Product Advisory

Issue Date: 31-March-2022

Sirius family 15x15mm substrate manufacturing process change

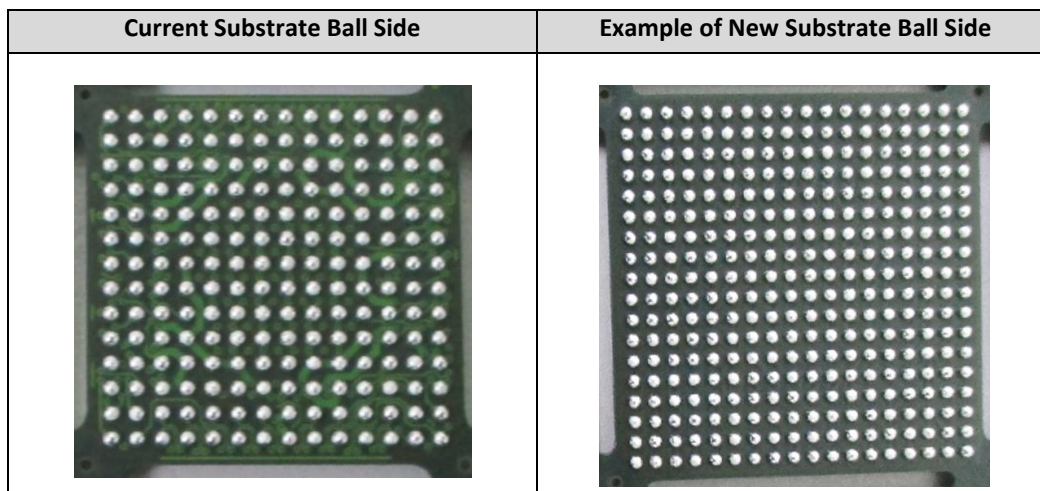
Changing substrate manufacturing process to sustain substrate supply. A visible differences on substrate ball side.

Current substrate manufacturing tooling EOL. Substrate supplier is changing to alternate substrate manufacturing process in sustaining substrate supply.

The alternate substrate process line have been qualified and running Sirius 19x19mm substrate.

The device specification will remain the same, which will ensure product electrical performance remains the same. Appropriate electrical characterization and reliability qualification has been performed on representative products to ensure normal parametric distribution, consistent electrical performance, and reliability.
